CITY OF PORTLAND BUILDING PERMIT

Located At 125 YORK ST

Job ID: 2012-04-3816-MF 3

TO: CITY OF PORTLAND PLANNING AUTHORITY
DATE: APRIL 14, 2011
RE: REPLY TO LEVEL III SITE PLAN REVIEW COMMENTS DATED
APRIL 12, 2011

4 Northeast Elevation
SCALE: 1/8" = 1'-0"

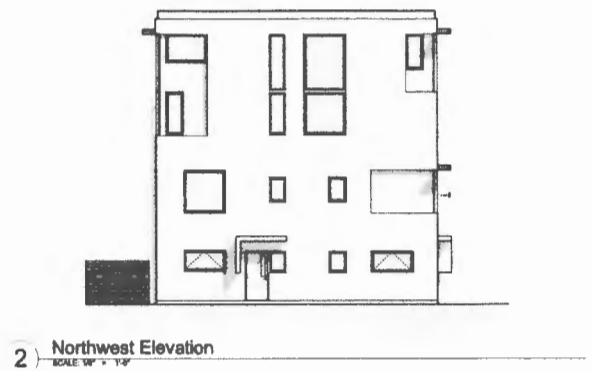
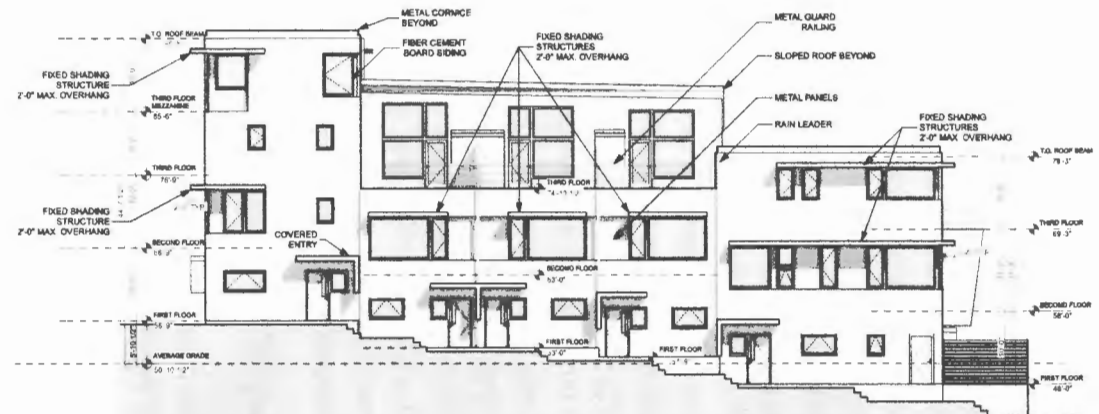
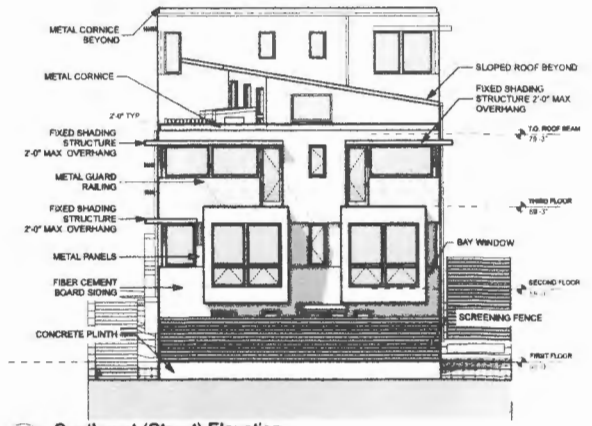
I have reviewed new elevation plans for this project. The e-mail submittal shows the same average grade of 50.88 feet. However the height to the roof beam has been reduced to 40.66'. The maximum building height is 45'. The revised building height is meeting the R-6 zone requirements.

The only major change of note is that the overall height of the building has come down relative to average grade. The tallest part of the building (top of roof beam at the rear/northwest) is now 40'-8" above average grade (WAS 44'-7 1/2" above average grade). The floor heights and average grade are unchanged from before.

1 **SOUTHWEST ELEVATION**

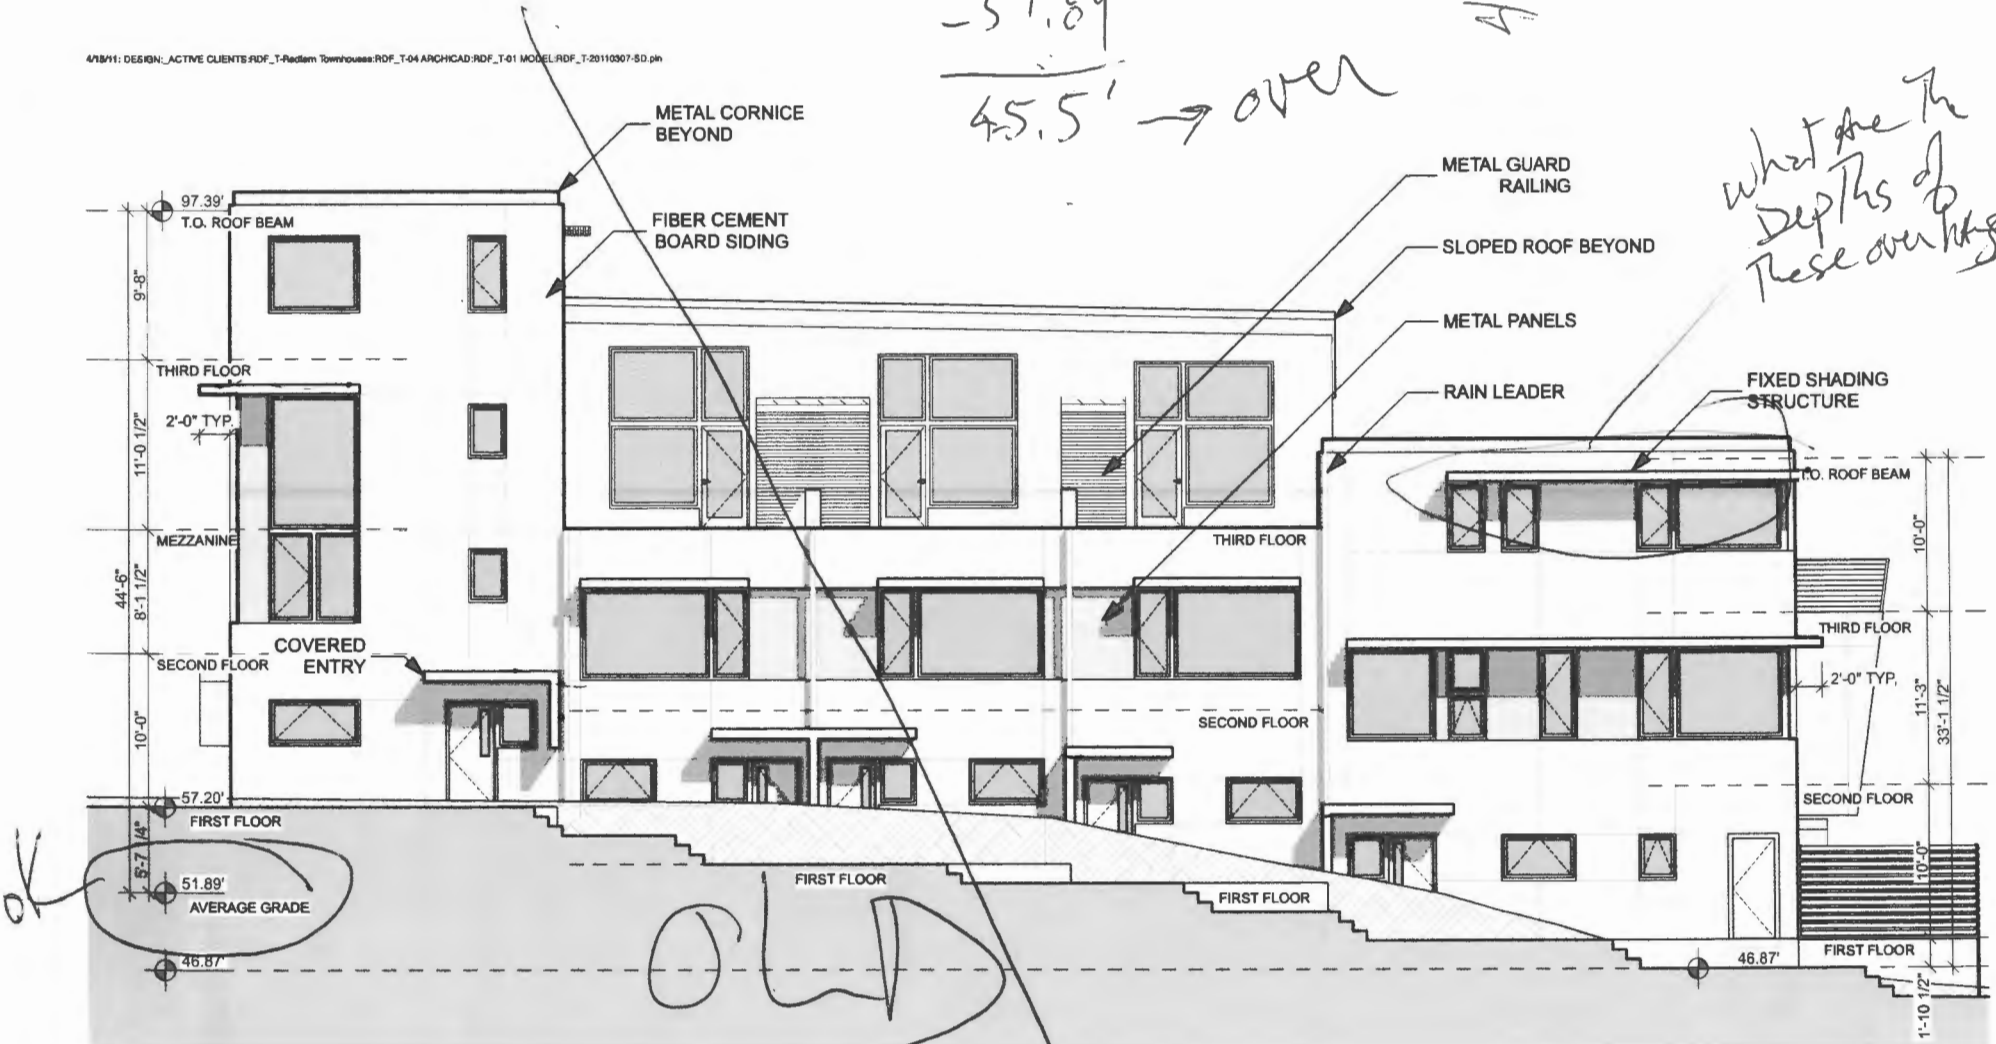
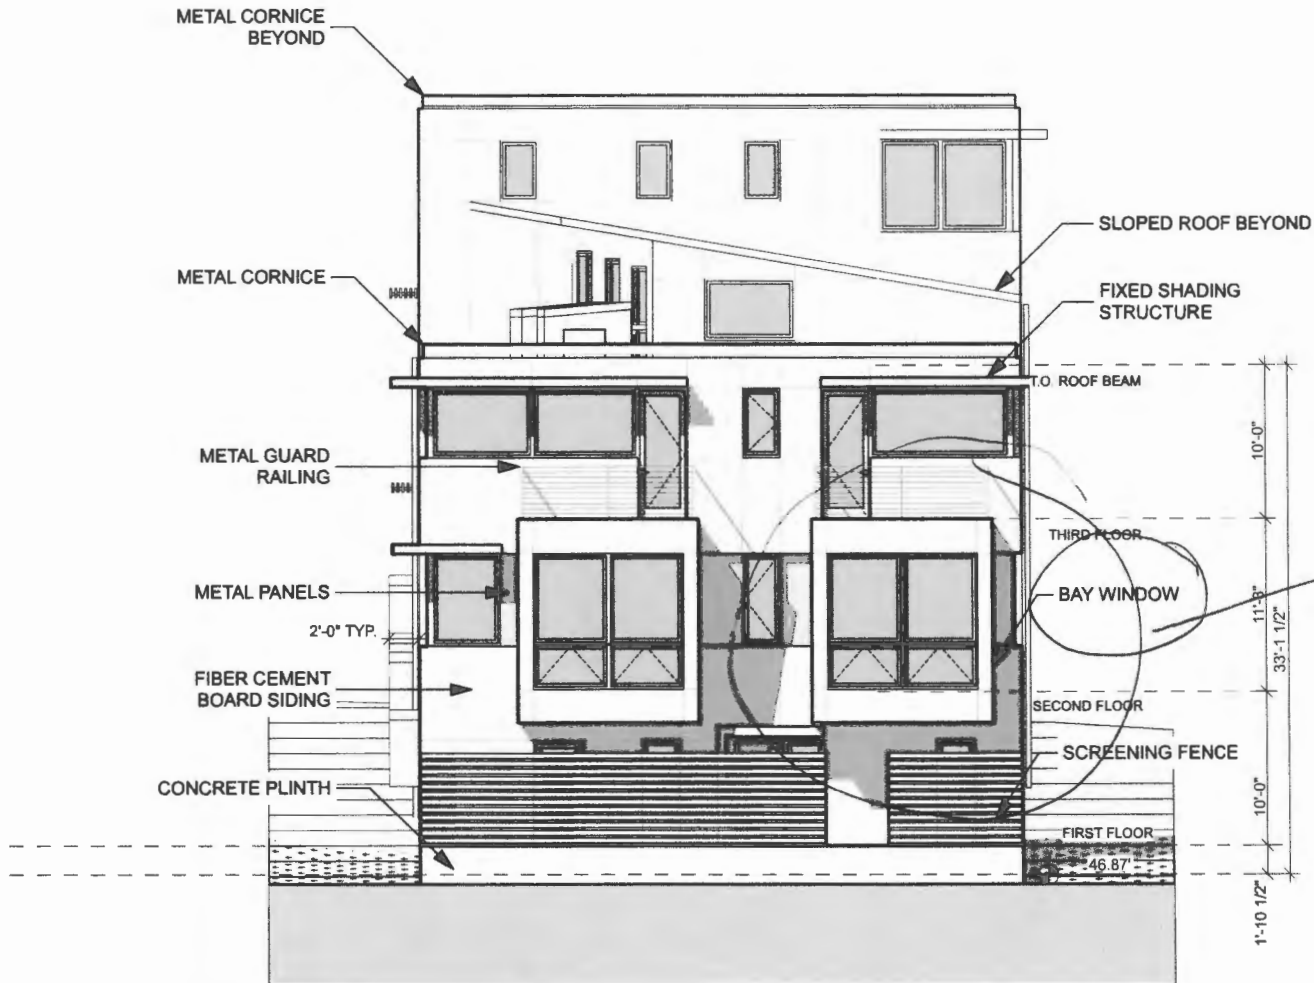
- over 45'*
2. I was given the average grade, but I do not see the elevation of the top of the highest roof beam. Before I can determine the height of this building I would need to see that figure.

- No PL*
3. The building elevation sketches lead me to believe that the proposed building may be 4 stories and not three stories. I would need more information to analyze that compliance. If it turns out that this building is actually 4 stories, then the side setbacks are wrong on the plans. 12' instead of 10' would be required.

Please see the attached, revised building elevation. The roof beam at the tallest part of the building is 44'-6" above grade.

See again the attached, revised building elevation. The back two units have a mezzanine level between the second and third floor. As per 2009 IRC, Section R202 (p. 17), Definitions: Mezzanine, Loft. "An intermediate level or levels between the floor and ceiling an any story with an aggregate floor area of not more than one-third of the area of the room or space in which the level or levels are located."

1 Mezzanine/Third Floor

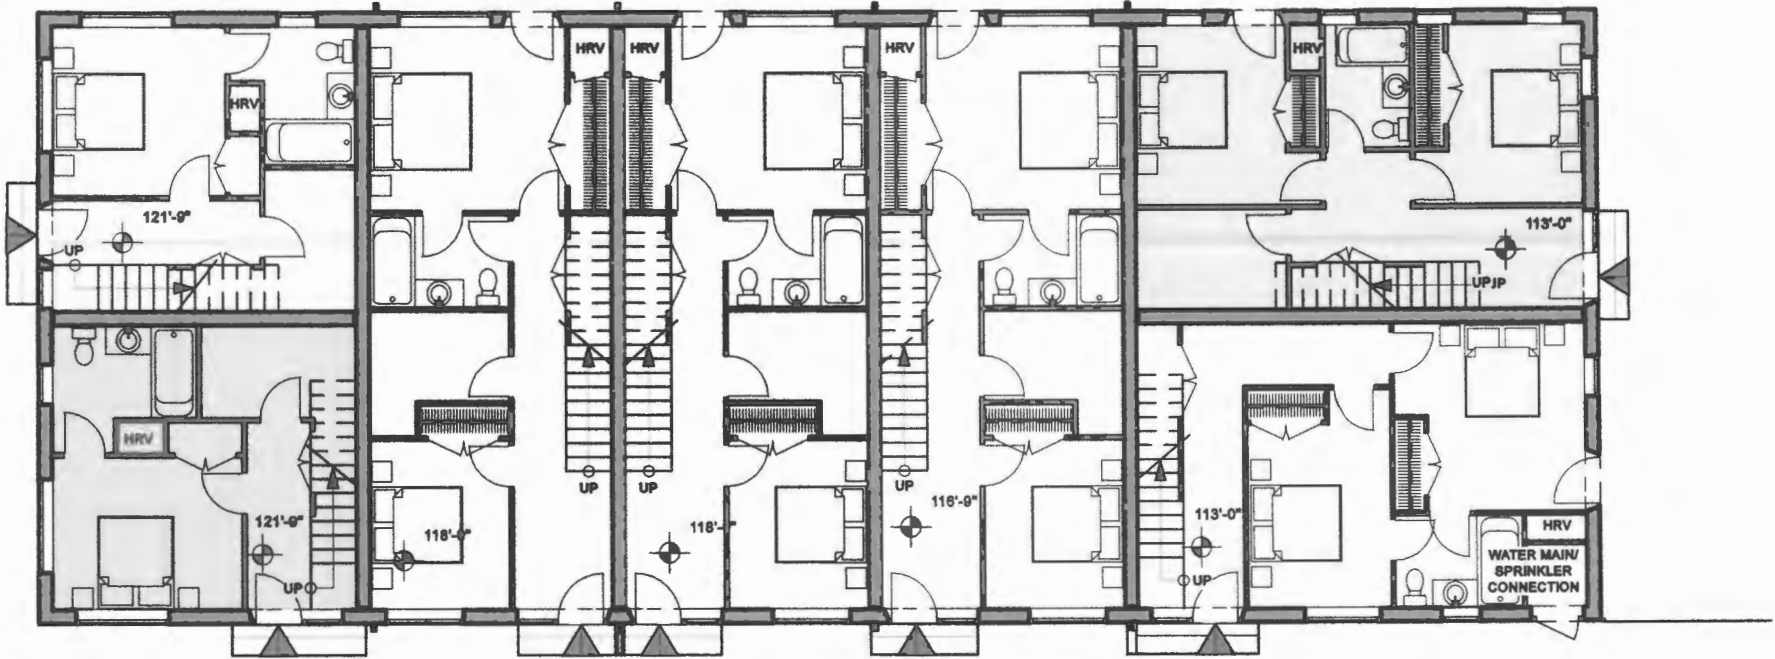
↓ Separate - I consider this a floor
